Planning Officer's Report – LDCA NOVEMBER 2020

APPLICATION	2020/46 – Proposed Covered Area at the Rear, The Consulate Hotel
PERMISSION SOUGHT	Permission in Full
REGISTERED	9 th June 2020
APPLICANT	Hazel Wilmot
PARCEL	JT040046
SIZE	0.34 acres (1402m ²)
LAND OWNER	Private
LOCALITY	Main Street, Jamestown
ZONE	Intermediate Zone
CONSERVATION AREA	Jamestown Conservation Area
CURRENT USE	Hotel
PUBLICITY	The application was advertised as follows: <ul style="list-style-type: none">▪ Sentinel Newspaper on 11th June 2020▪ A site notice displayed in accordance with Regulations.
EXPIRY	25th June 2020
REPRESENTATIONS	None Received
DECISION ROUTE	Delegated / LDCA / EXCO

Diagram 4: East Elevation

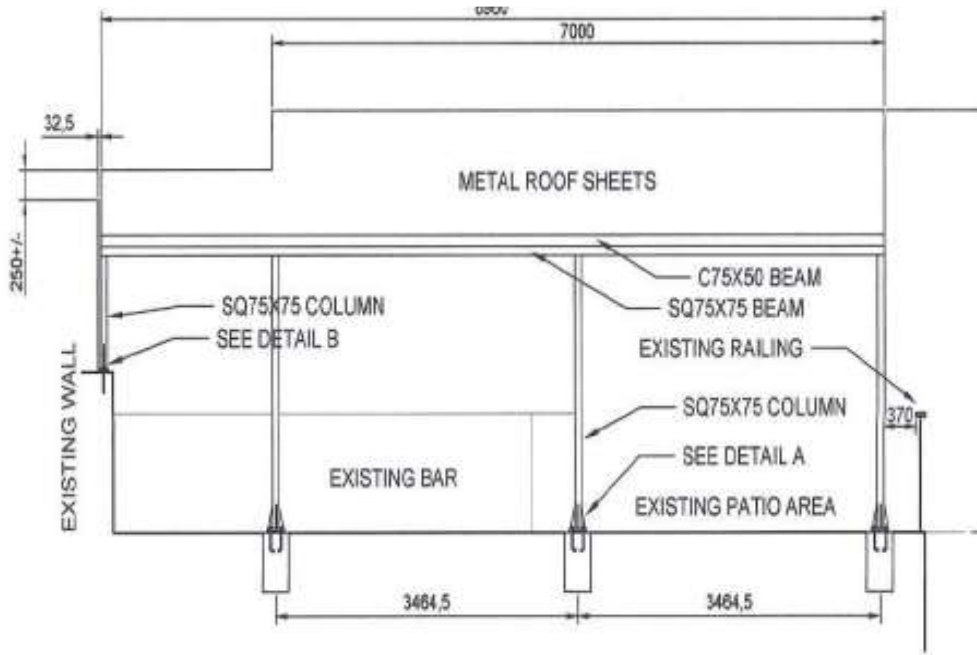
- planning policy requires design to be appropriate to the character of the setting and appearance of historic asset, and to protect and enhance the Jamestown Historic Conservation Area as borne out in LDCP policies BH 1c, 2, 3 and 5;
- a more sympathetic design would be more appropriate to this important setting;
- the roof line would be best turned at right-angles so the roof line follows those of the adjacent back buildings;
- external materials and overall design including details should be more carefully considered to reflect the high quality of the existing Hotel;
- LDCP (Appendix 3) briefly describes the importance of the Jamestown Historic Conservation Area and points out the significance of the back buildings.

The proposed structure to cover the rear area to provide protection from the weather and additional space for entertainment is simple in its design and construction, which could be located in most settings including historically sensitive areas. The issues is design and orientation of the roof. The roof ridge lines of the main buildings with elevation into Main Street is parallel to the highway, however, in the rear there are varying roof ridge lines; some are perpendicular with the main building and some are of similar orientation to the main buildings. On the application site, there are varying ridge lines for the out buildings. The ridge line of the proposed structure would sit just as comfortably as proposed and not affect the integrity of the area or the building.
